## Bethesda Downtown Design Advisory Panel

### Meeting Minutes

**PROJECT:** 7070 Arlington Road

**DATE:** February 24, 2021

**FIRE ACCESS PLAN**

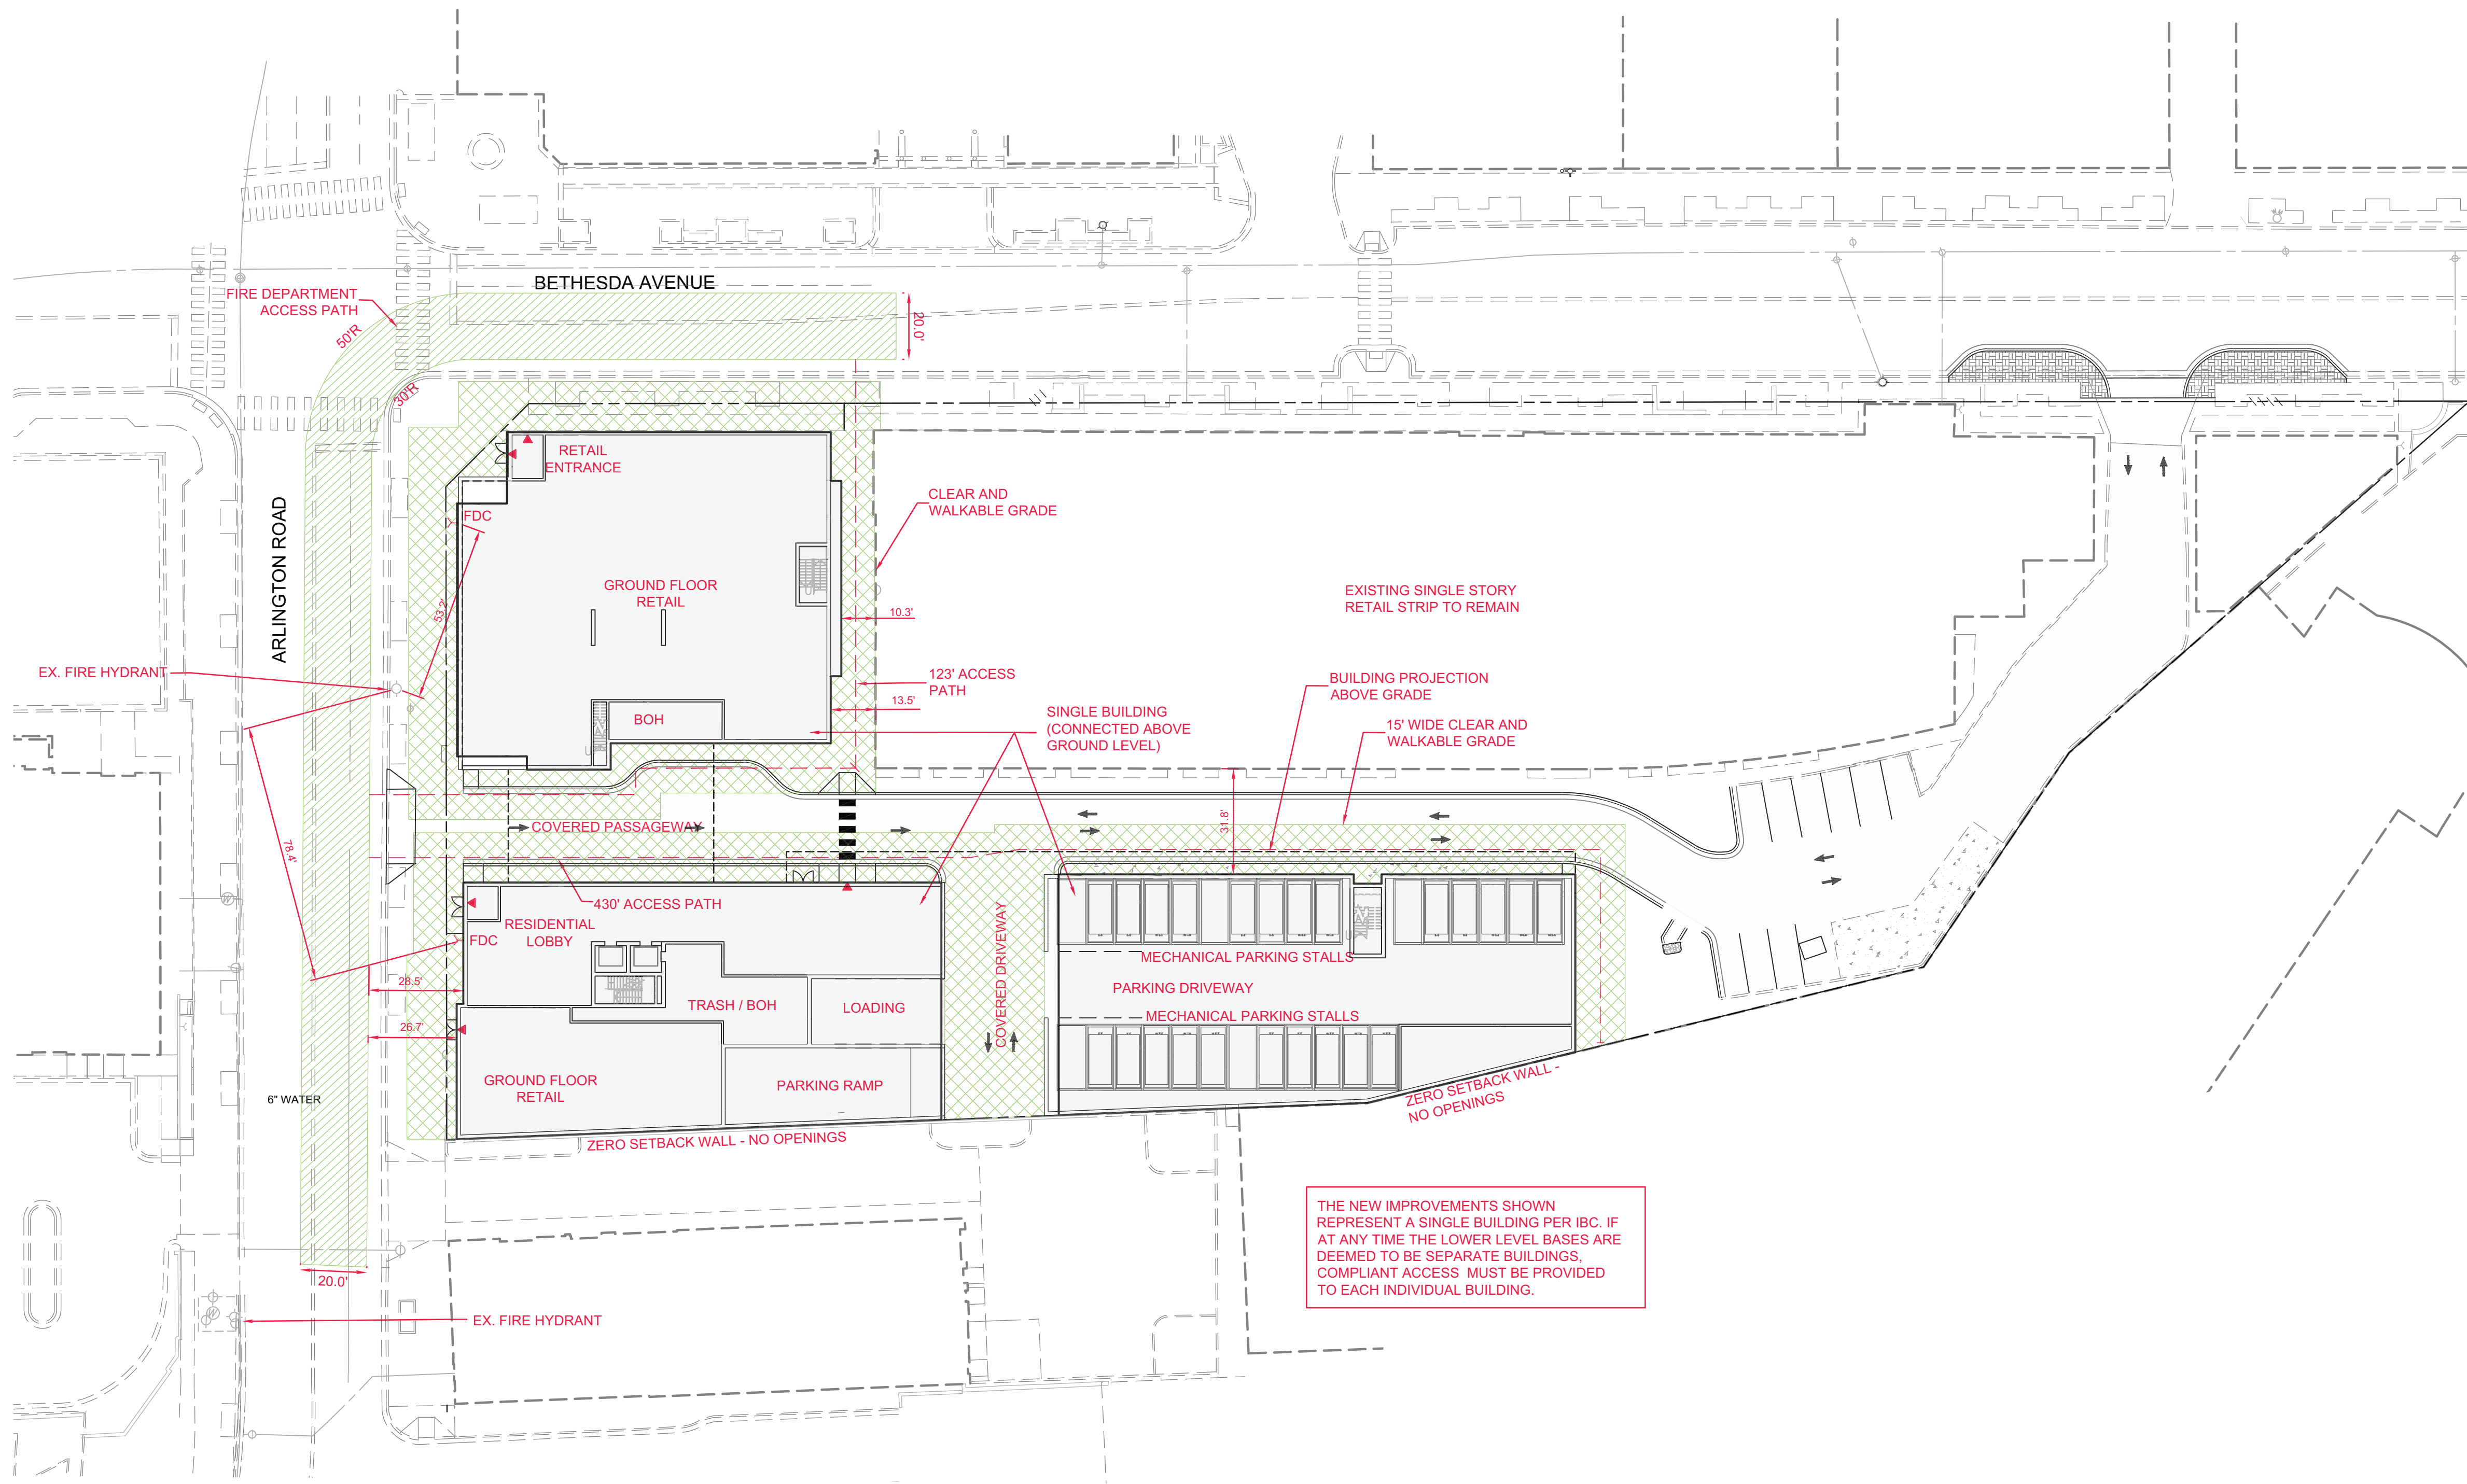
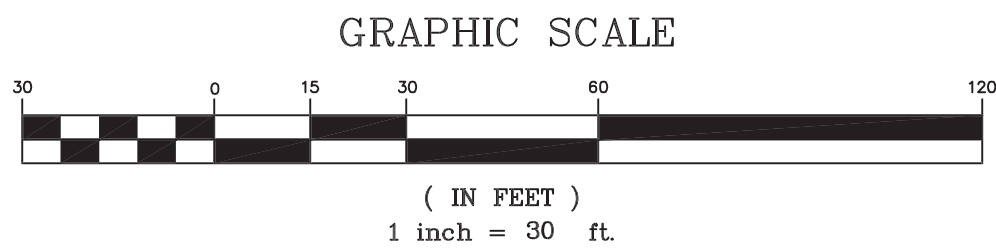
**\*\*\* Floorplan for level of main access to be submitted at site plan \*\*\***

NOTE: THIS FIRE ACCESS PLAN IS PRELIMINARY. A FINAL APPROVAL BY MCDPS FIRE ACCESS & WATER SUPPLY (INCLUDING A PERFORMANCE BASED DESIGN MEMO IF APPLICABLE) WILL BE REQUIRED AT THE TIME OF SITE PLAN, SHOWING THE PROPOSED BUILDING FLOOR PLANS & ELEVATIONS.
